Project	IEEE 802.16 Broadband Wireless Access Working Group < http://ieee802.org/16 >	
Title	RS Location Report for Neighbor Discovery	
Date	2006-01-16	
Submitted		
Source(s)	<p>Kanchei (Ken) Loa, Yi-Hsueh Tsai, Voice: +886-2-2739-9616 Shiann-Tsong Sheu, Yung-Ting Lee, loa@iii.org.tw Hua-Chiang Yin, Chih-Chiang Hsieh, Frank C.D. Tsai, Youn-Tai Lee, Heng-Iang Hsu Institute for Information Industry 8F., No. 218, Sec. 2, Dunhua S. Rd., Taipei City, Taiwan.</p> <p>Peter Wang, Adrian Boariu, Shashikant Voice: +1 214-912-4613 Maheshwari, Yousuf Saifullah, Tony peter.wang@nokia.com Reid, Haihong Zheng Nokia 6000 Connection Drive, Irving, TX [add co-authors here]</p>	
Re:	IEEE 802.16j-06/034: "Call for Technical Proposals regarding IEEE Project P802.16j"	
Abstract	This contribution proposes procedures for RS location report for neighbor discovery	
Purpose	Text proposal for 802.16j Baseline Document	
Notice	This document has been prepared to assist IEEE 802.16. It is offered as a basis for discussion and is not binding on the contributing individual(s) or organization(s). The material in this document is subject to change in form and content after further study. The contributor(s) reserve(s

Table xxx: Relay location report (part 1)

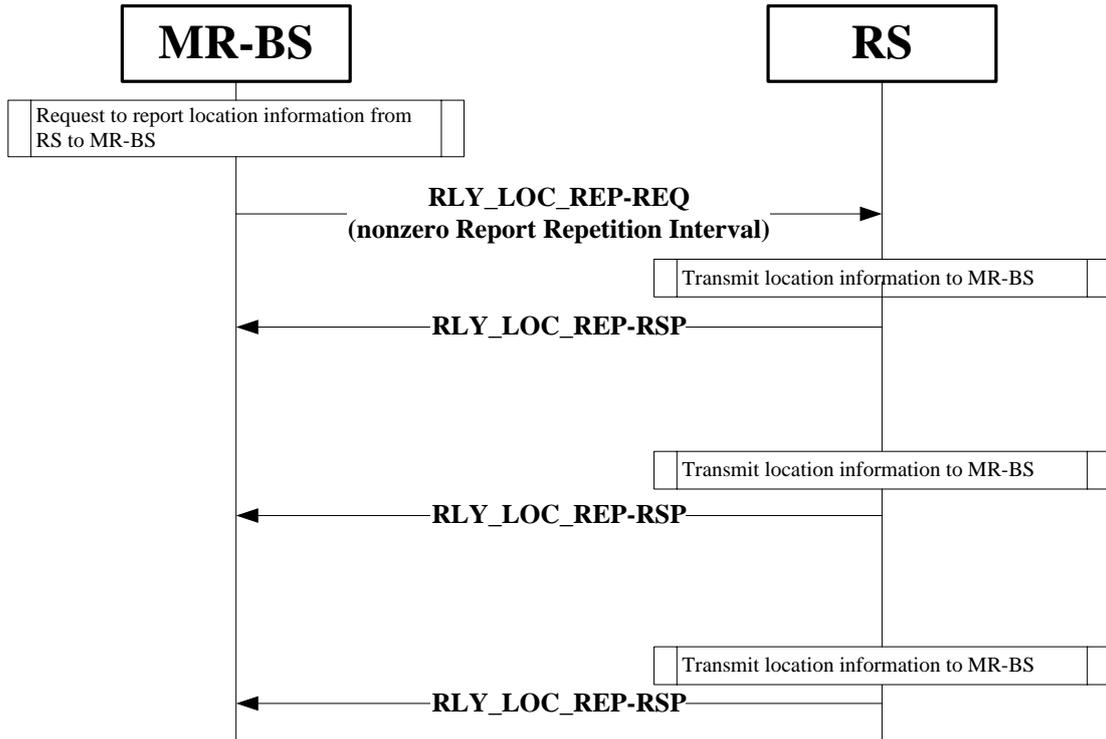
The message sequence charts (Table xxx and Table yyy) and flow charts (Figure xxx and Figure yyy) define the RS location report process that shall be followed by compliant RSs and MR-BSs.
